Your Comment on the Ōhoka Residential Subdivision

Fig 1. Proposed Development Layout

Fig 2: Proposed Road and Boundary Interfaces

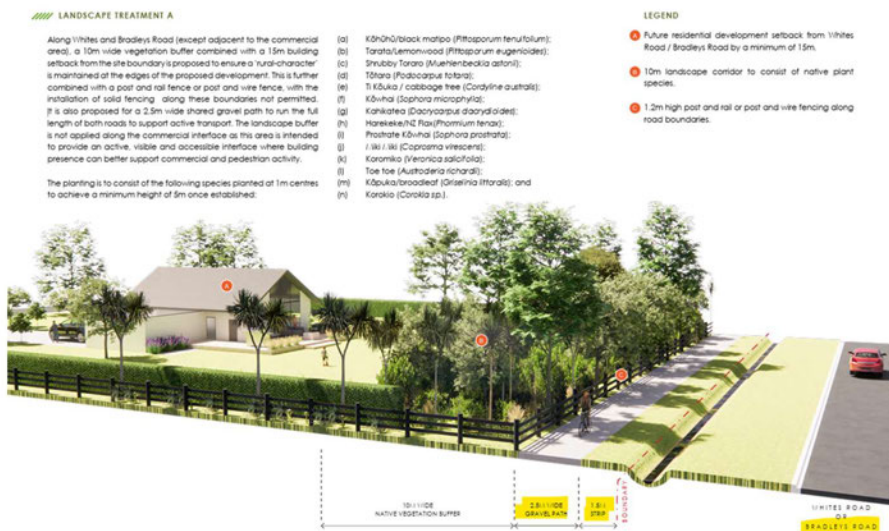
2.2.1.1. *The applicant states: "It is also proposed for a 2.5m wide shared gravel path to run the full length of both roads (Whites Road or Bradleys Road) to support active transport."*

2.2.2. We raised this issue in our previous submissions because there is very limited room at our frontage between Bradleys Road, the Council berm and drainage ditch, and our property boundary. Proposed condition 67(d) says the shared paths will be located on land to vest as road reserve, so we cannot say that the current plan definitely encroaches on our title. However, the words "full length" and the drawings leave the position at [REDACTED] unclear.

2.2.3.1. The applicant must provide a surveyed plan and cross-section confirming that the path, drainage works, batters and construction area will remain outside [REDACTED]. If the path cannot be accommodated within road reserve at our frontage, the wording should be changed to make the exclusion clear.

Photo 2: View South from [REDACTED]

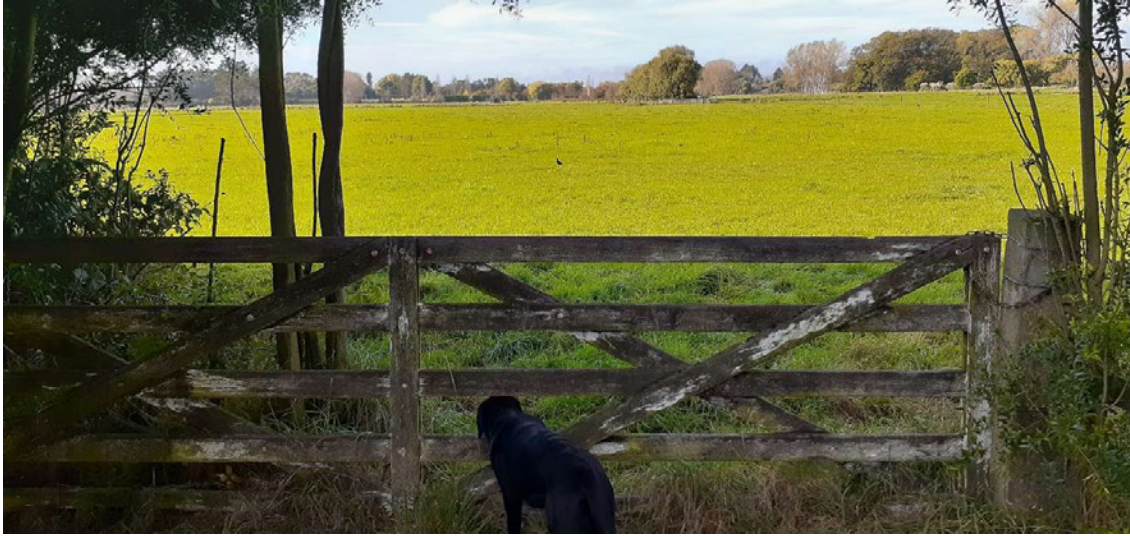
3.4.2. There is no mitigation for the loss of views from our property. How can there be when you are taking expansive views across open fields and replacing them with a 4-metre hedge? For this reason, we request that the Panel decline the application.
